PN 21497155 A

MODEL: All currently supported Eclipse® and eQuinox™ models

ISSUE: Improvement to ATF Stepper Motor

Figure 1 – ATF Assembly

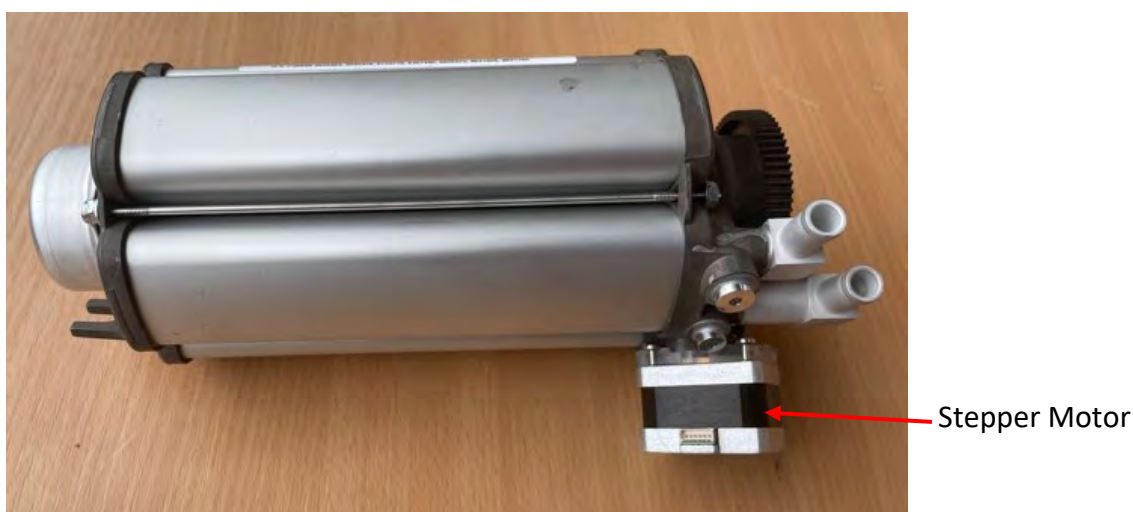
NOTES: As part of our ongoing continuous improvement program, we have implemented the addition of an M3 securing screw to the shaft on the stepper motor used in our ATF parts (see figures 2 and 3 below for details). This change will further enhance the strength and stability of the component. Table 1. below lists current ATF assemblies affected by this change.
